ControlLogix DeviceNet Interface Module

Catalog Numbers 1756-DNB, Series C and D

About This Publication

Publication 1756-RN660C-EN-P - February 2011

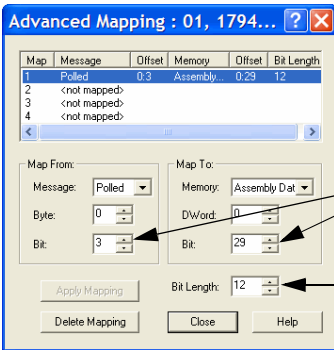
Corrected Anomaly	Description
Connection Failed error type resulted from bridging over DeviceNet via a 1756-DNB module and monitoring device parameters	<p>CORRECTED: If you bridged to a device on a DeviceNet network via a 1756-DNB module using firmware revision 11.002 or 11.003 and attempted to monitor the device's parameters in RSNetWorx for DeviceNet software the connection failed and device monitoring stopped.</p> <p>Typically this anomaly occurred 5..10 seconds after device monitoring began. When the anomaly occurred, a connection failed type error appeared in the RSNetWorx for DeviceNet software error window.</p> <p style="text-align: right;">Lgx00107704</p>
